CITY OF PANAMA CITY BEACH

June 3, 2026

ADDENDUM NO. 2

PCB26-16 POLICE K-9 TRAINING FACILITY

BUILDING PLAQUE
ELEVATION

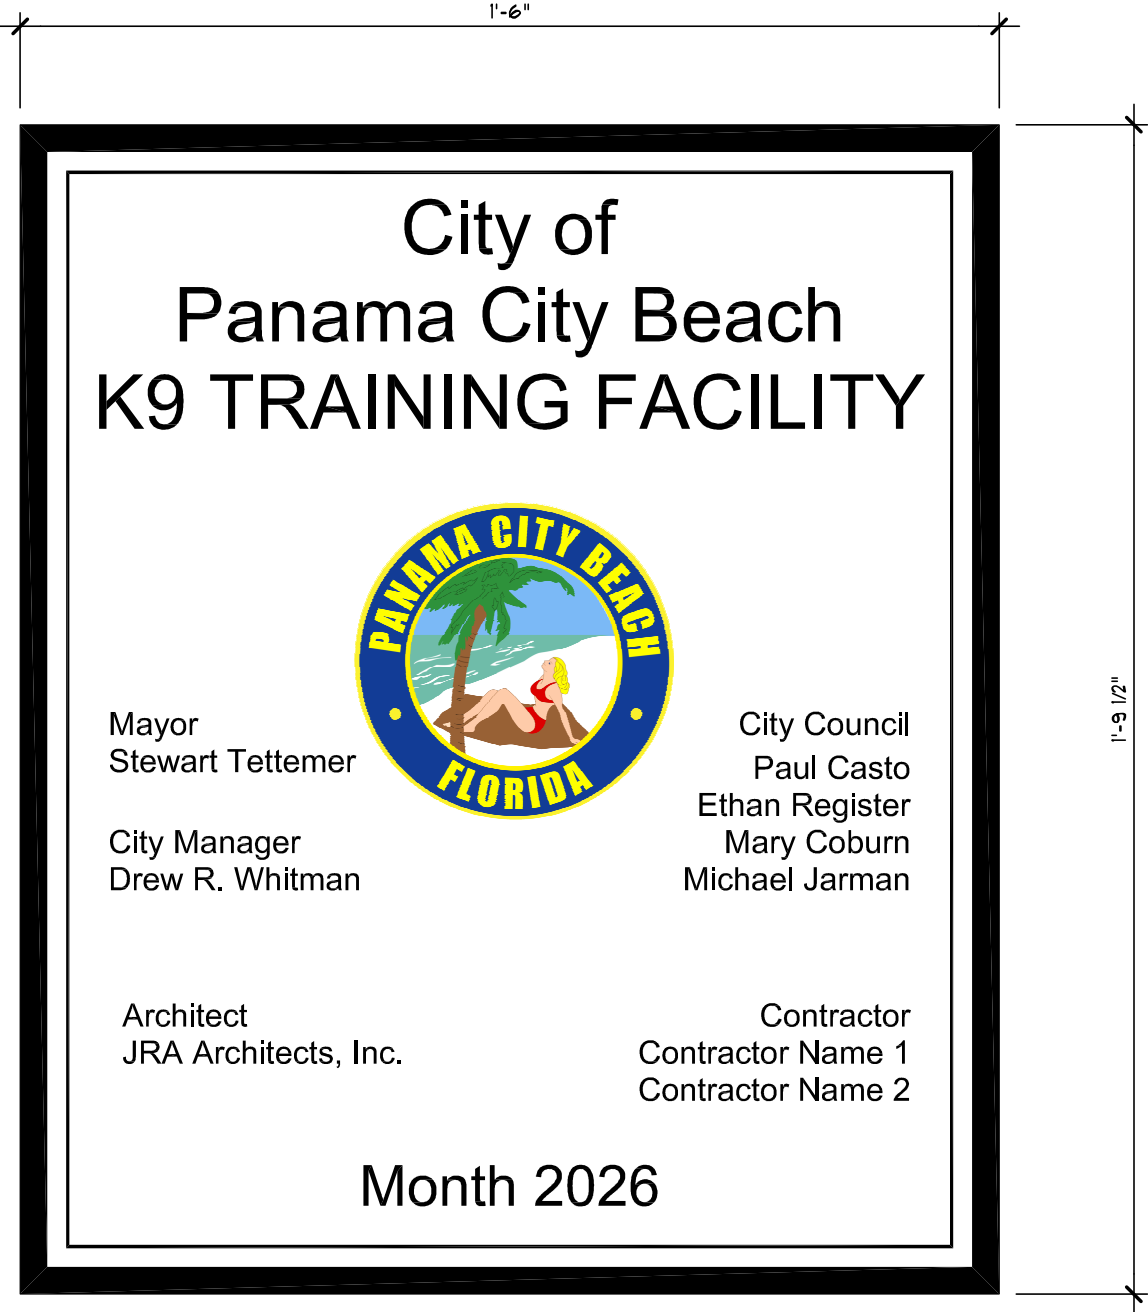
3. Additionally, the documents reference a metal plaque, but no details or location appear to be provided. Please confirm the required plaque size, material/finish, contour/profile, mounting method, and installation location.
 - A. The building Plaque is described in the specifications section 10 14 00 paragraph 2.04. The location will need to be coordinated with the Owner prior to installation. For size and content see attached Building Plaque elevation.

SITE PLAN - ELECTRICAL
 SCALE: 1" = 20'-0"
 0 10' 20' 40'

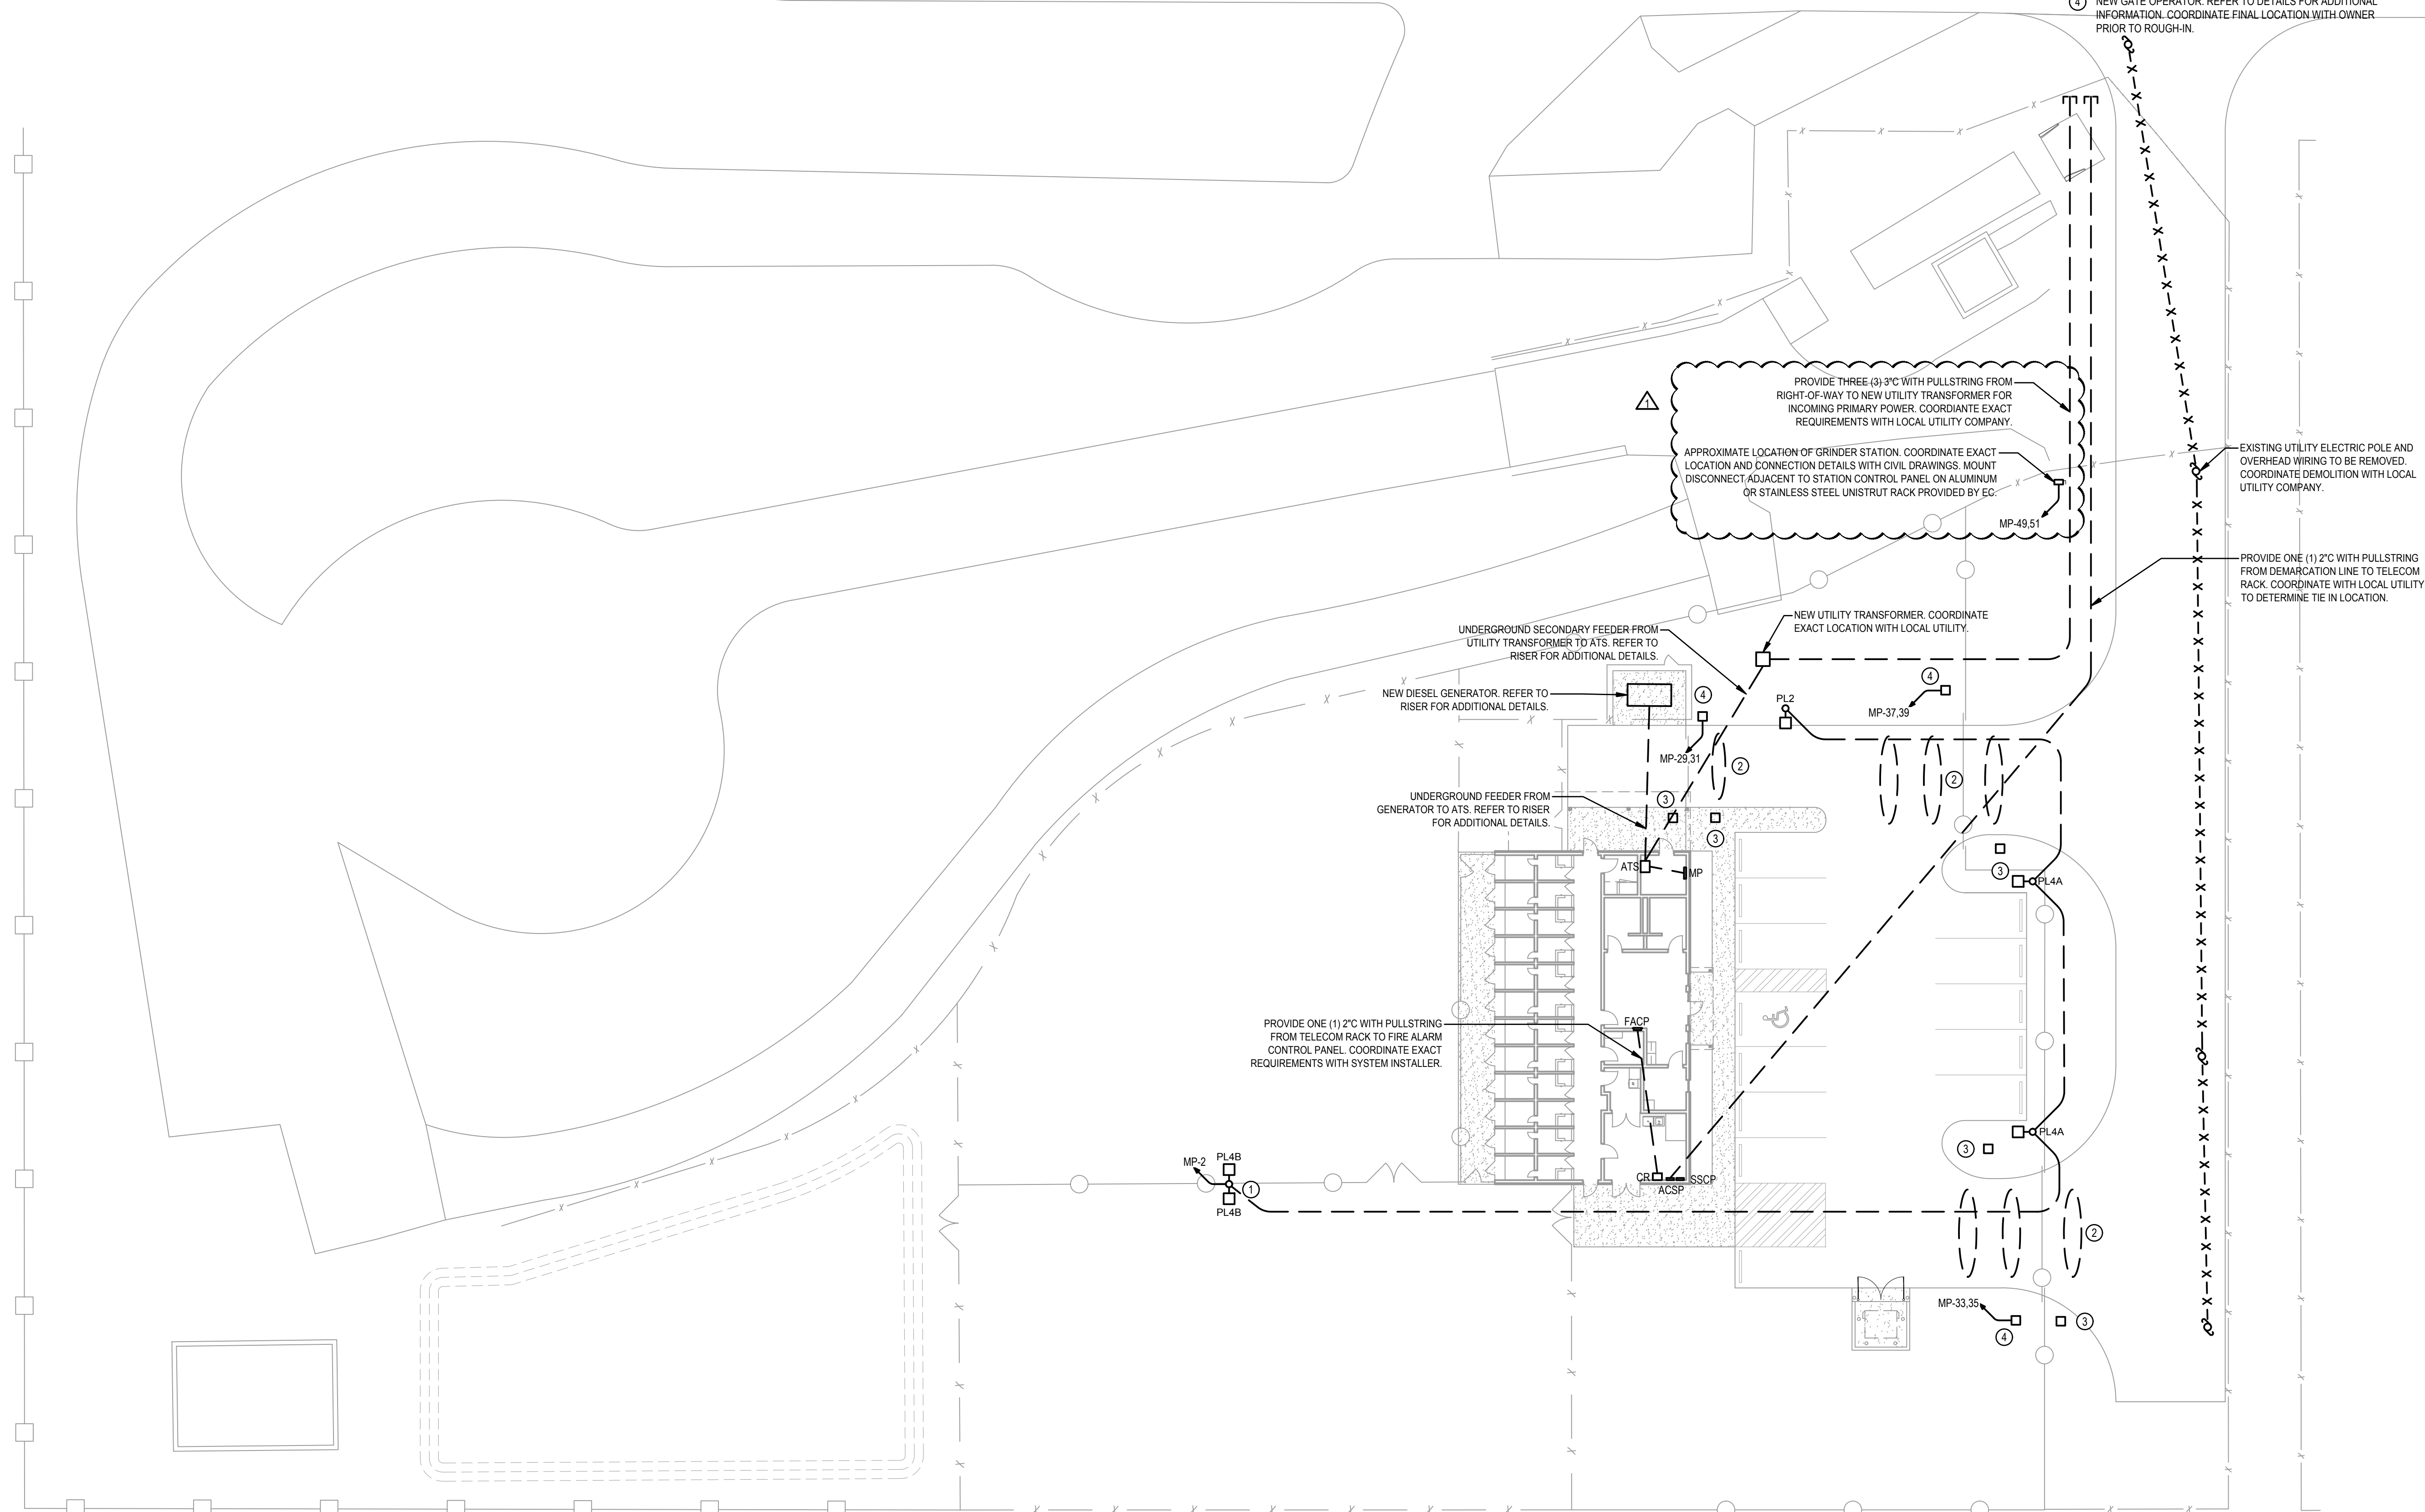
4. Can you provide additional information regarding the grinder station, it is not reflected on the electrical plans.

A. See attached Revised Electrical drawings E1.1, E6.2, & E7.1.

APPROXIMATE LOCATION OF GRINDER STATION. COORDINATE EXACT LOCATION AND CONNECTION DETAILS WITH CIVIL DRAWINGS. MOUNT DISCONNECT ADJACENT TO STATION CONTROL PANEL ON ALUMINUM OR STAINLESS STEEL UNISTRUT RACK PROVIDED BY EC.

WALL BEARING PLAN
 SCALE: 1/4" = 1'-0"
 NORTH

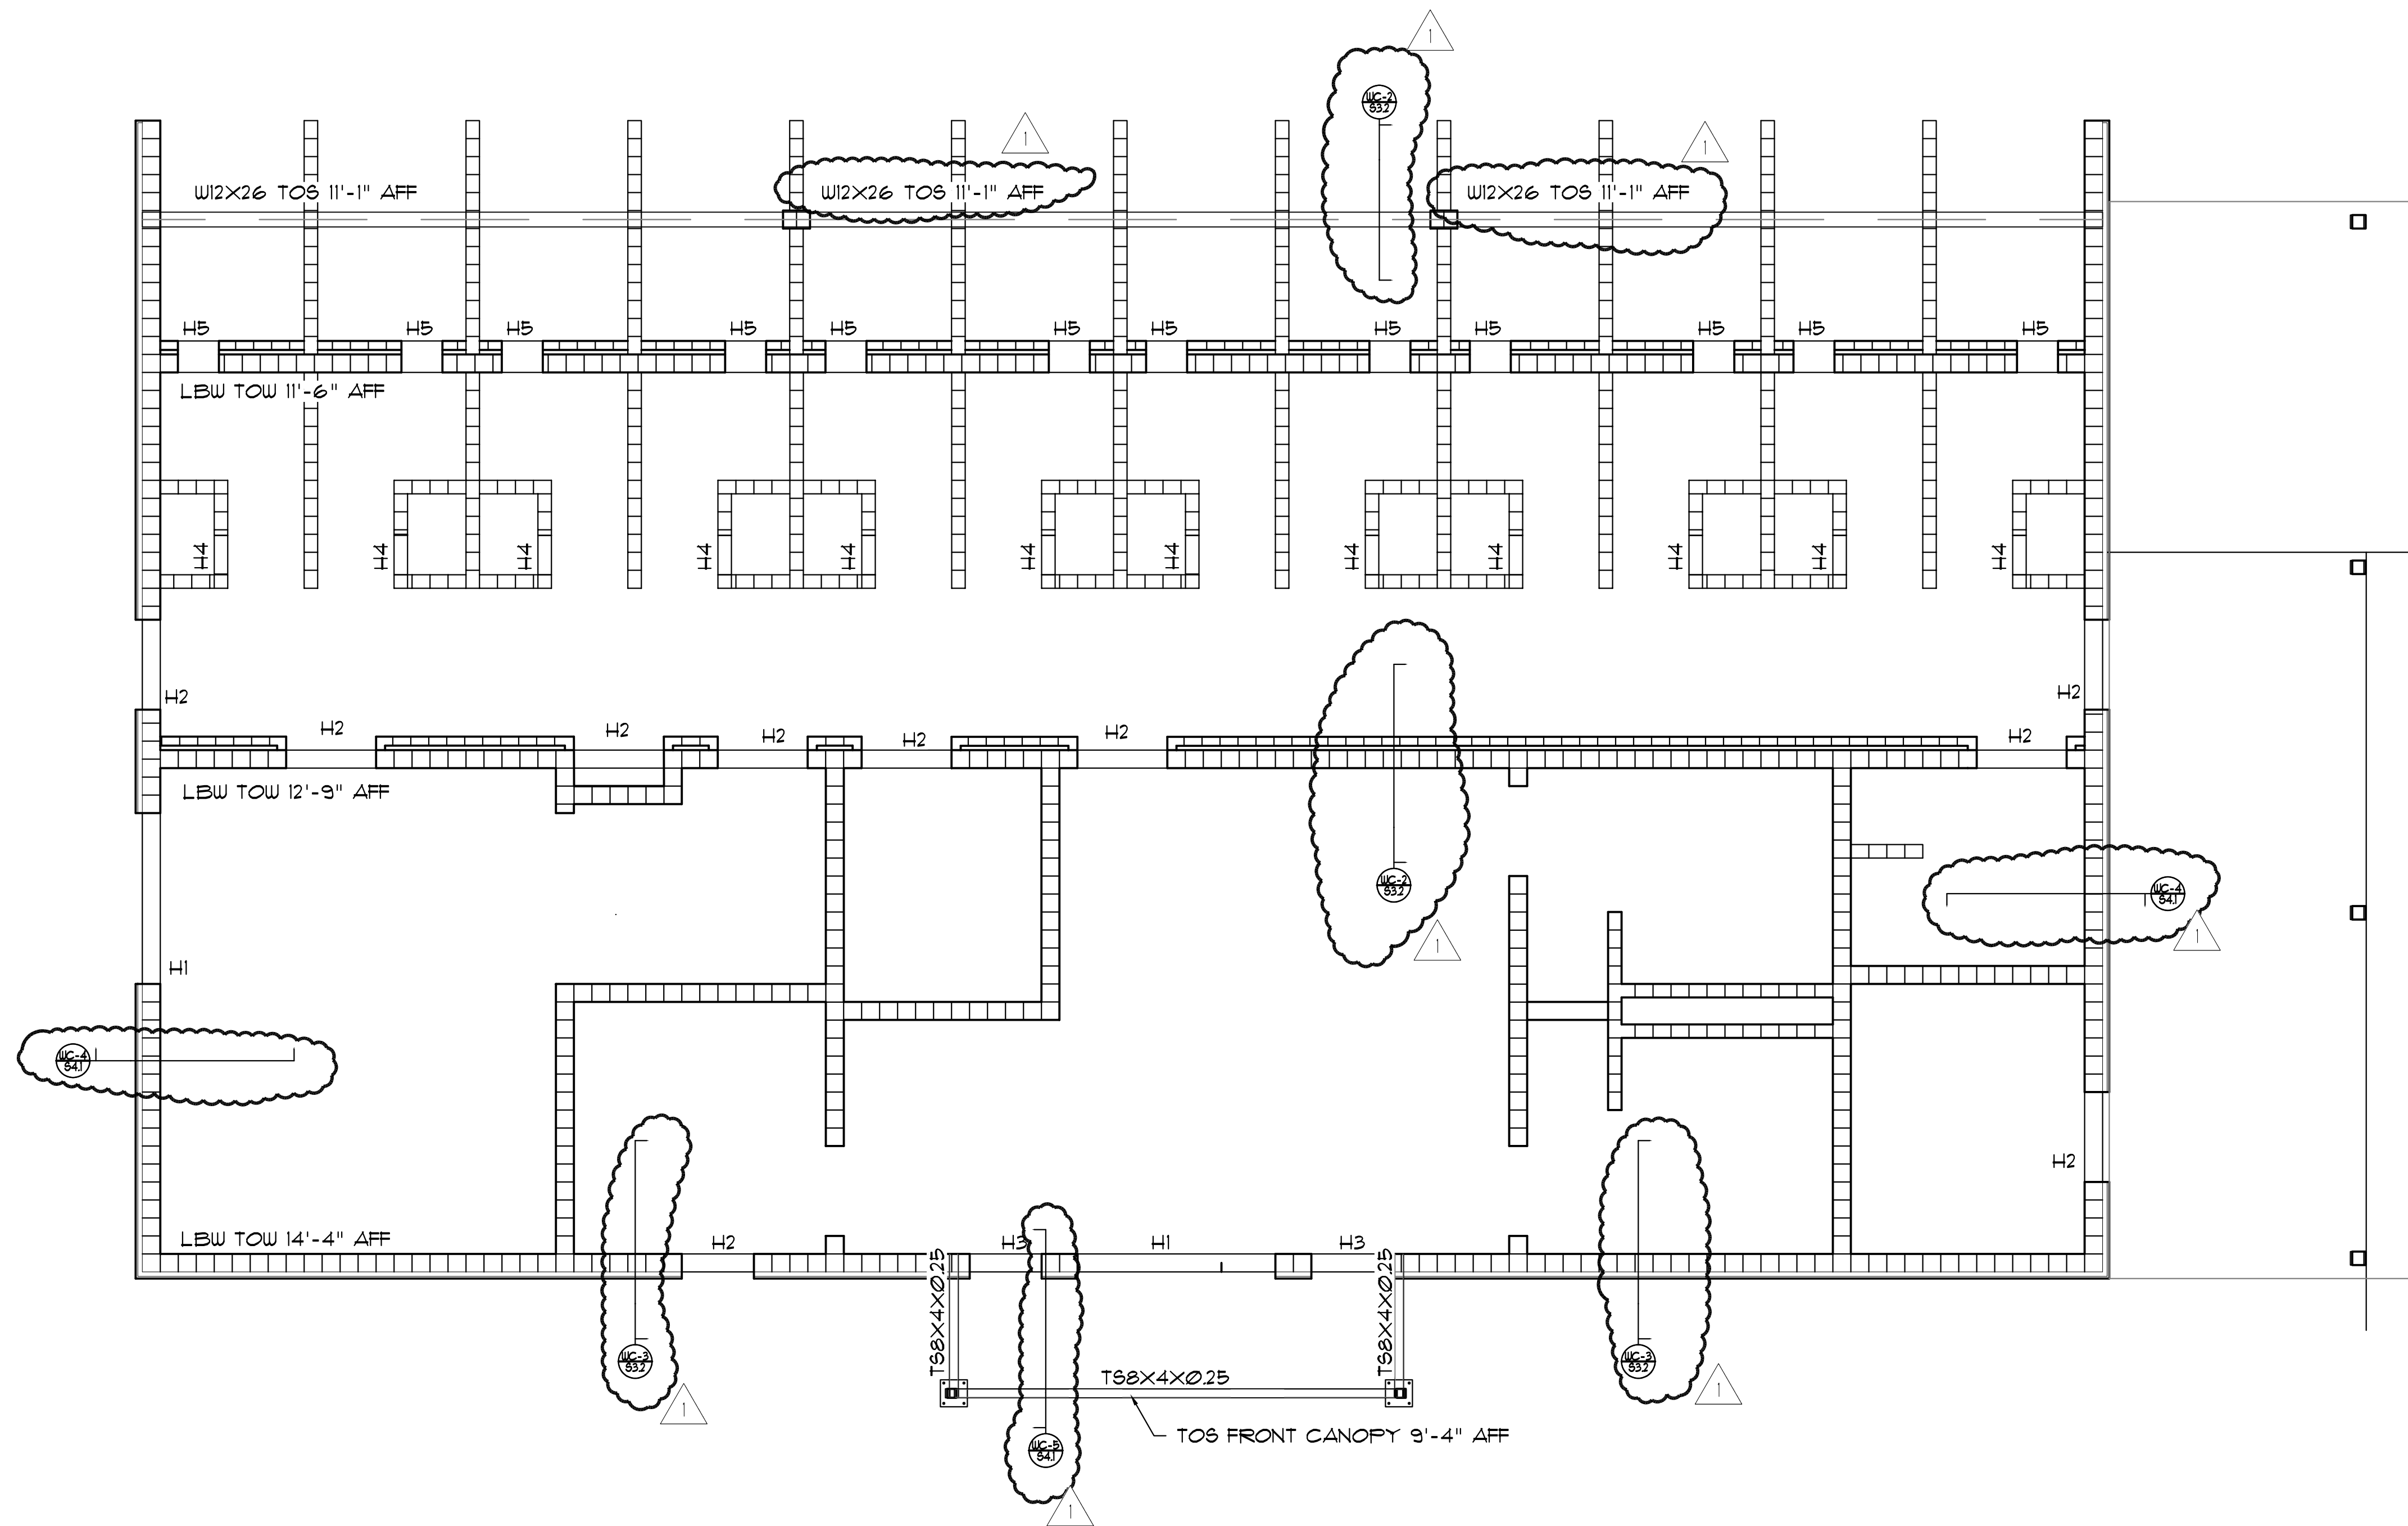
16. Detail WC-1 on sheet S3.2 shows a flange beam. Sheet S2.1 shows it for an HSS8X4X1X1/4 tube. Which is correct? If the flange beam, what size is this beam?

A. See attached revised structural drawing S2.1 and referenced sections. (Beam is to be W12x 26)
